American River Flood Control District

Request from the City of Sacramento to Allow a Portion of the Two Rivers Trail on Top of the Levee

Staff Report

SUBJECT: TWO RIVERS TRAIL (PHASE II)

Attachment 1: Segment Map

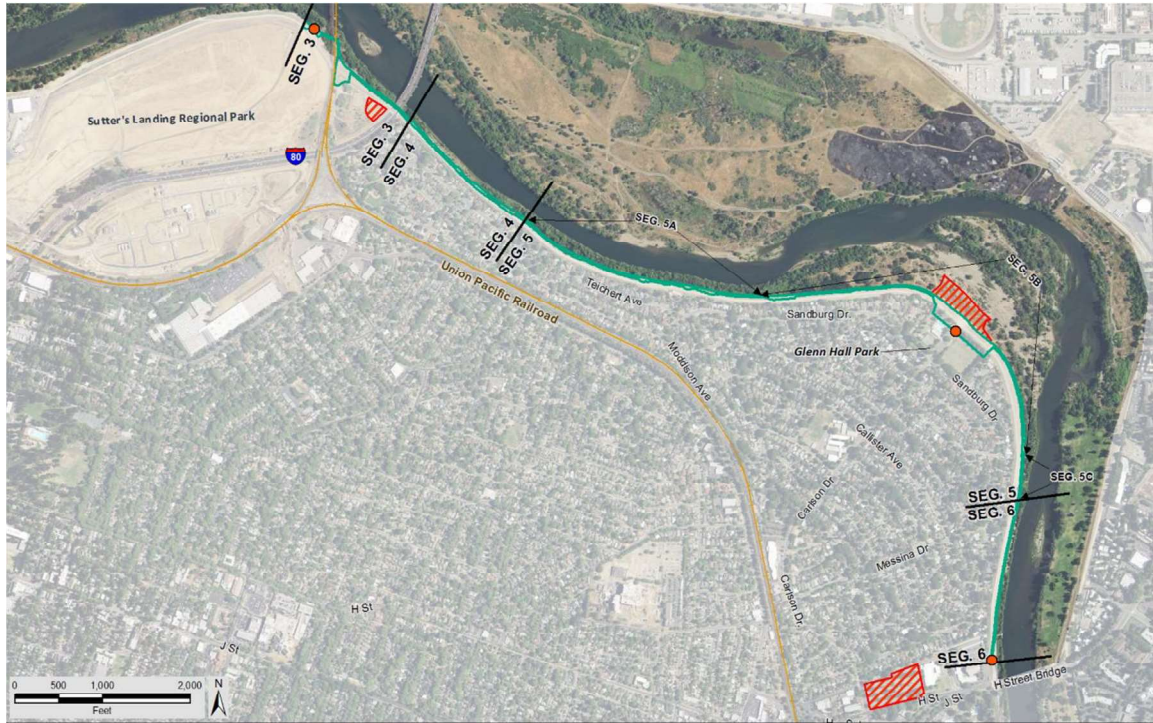
The City has performed an exhaustive study to show the stability and safety of the mid-levee alternative. The USACE coordination, higher construction costs, increased biological impacts, and public comments received during the environmental document review period have led us to the conclusion that constructing a mid-levee trail through segment 4 poses enough of a risk to the implementation of the project to make it infeasible. We are requesting a variance to **construct the trail on top of the levee in segment 4 only**. The remainder of the trail is still planned along the levee toe, as per the District's policy.

Per the District's Recreational Trails Policy, Section 3a, the District can allow a crown trail where any other alternative is not feasible. This segment lends itself best to a shared levee top, being relatively short and straight. This means that potential conflicts are contained within a short area with the best possible sight distance.

1. The Board of Trustees acknowledge the City conducted a considerable effort to develop an off-crown alternative for the entirety of the proposed Two Rivers Trail but faced significant challenges in trying to span the reach of Segment 4 near the 1986 washout; and
2. The Board consent to allowing the short reach of Segment 4 to be constructed on the levee crown.
